**STAFF REPORT - DESIGN REVIEW E  
FINDINGS AND RECOMMENDATION**

FILE NUMBER: DRE/SD 19-26000011

LOCATION: 550 NE 5th St., Gresham OR 97030

PROPOSAL: Type III Design Review E for the construction of one, three-story building with five single-family attached homes with associated site improvements and a Type II five-lot subdivision.

FIGURE 2: North Elevation. Facing NE 5th Street

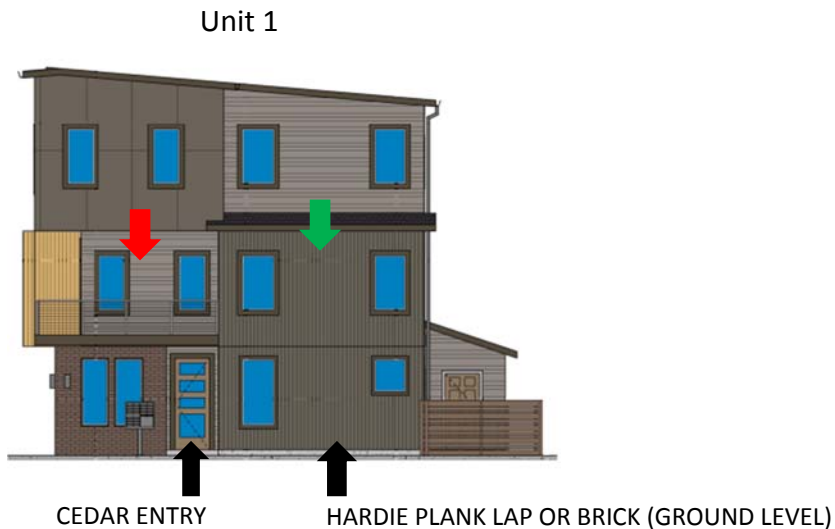
On the north elevation staff recommends the following (see Figure 2):

- The Hardie panel on the east half of the third level be extended down to the second level.
- The Hardie plank lap siding on the west half of the third level be carried down to the second level.

- The entry area be natural cedar (consistent with the east unit entries) and west of the entry, at the ground level, be Hardie plank lap siding or brick.

- b. On the north elevation, Hardie panel on the east side of the second level.
  - c. On the north elevation, Hardie plank lap siding on the west half of the second level.

- d. On the north elevation, natural cedar on the entry area and west of the entry (on the ground level) Hardie plank lap siding or brick.
12. Site Plan:
